TO: Mercedes-Benz Dealer Principals, General Managers, Sales Managers, Service Managers, Parts Managers	FROM: Gregory Gunther, Department Manager, Vehicle Compliance and Analysis, Engineering Services
RE: Recall Campaign Launch Notification Adjust Second Row Bench Middle Double Buckle MY20-21 167 (GLE-Class)	DATE: December 11, 2020

Recall Campaign Launch Notification			December 11, 2020
Campaign No. :	NHTSA ID	Campaign Desc. :	Adjust Second Row Bench Middle Double Buckle
2020110005	20V671	20P9290005	
<p>This is to notify you of the Recall Campaign Launch to adjust the second row bench middle double buckle in 55,326 Model Year (“MY”) 2020-2021 GLE-Class (167 platform) vehicles . The recall campaign will be visible on the www.safercar.gov website and may generate questions from customers. Affected VINs will be flagged in VMI as “OPEN” on December 11, 2020.</p>			
Background			
Issue	Mercedes-Benz AG (“MBAG”), the manufacturer of Mercedes-Benz vehicles, has determined that on certain Model Year (“MY”) 2020 - 2021 GLE-Class (167 platform) vehicles with 5 passenger seating, in certain circumstances while buckling the seatbelt, the middle seatbelt buckle could be pushed down below the s

Figure 3

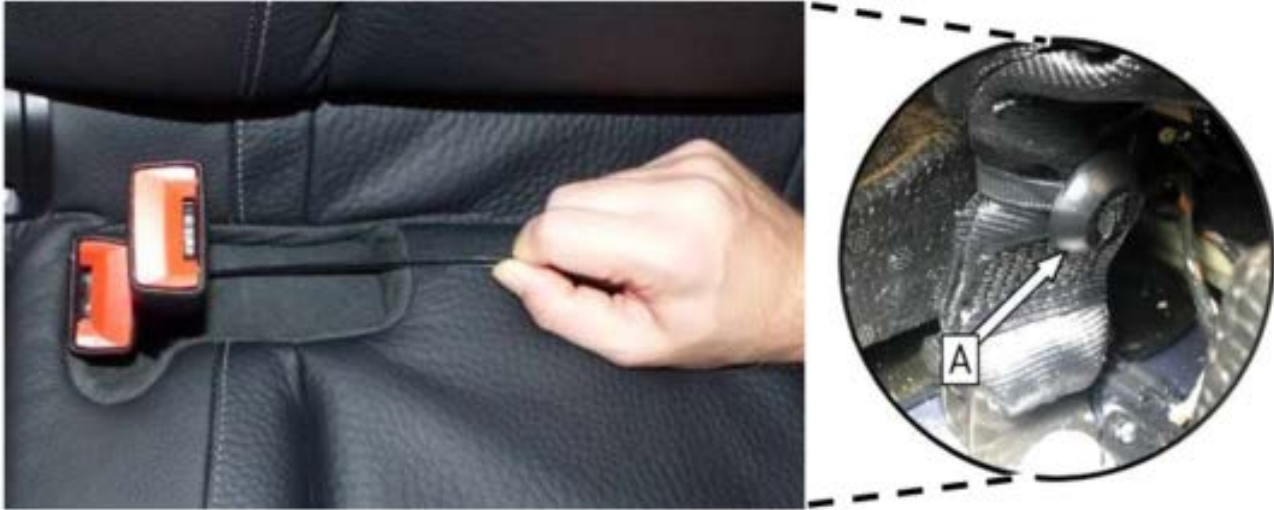
5. Then align "head" of cable tie with left-hand side as shown **(A, Figure 3)**.
6. Use side cutting pliers to cut off overhang of cable tie such that it is flush.
 - i** Make sure that no sharp-edged offcut is left over, as the rear seat cushion cover may otherwise be damaged.
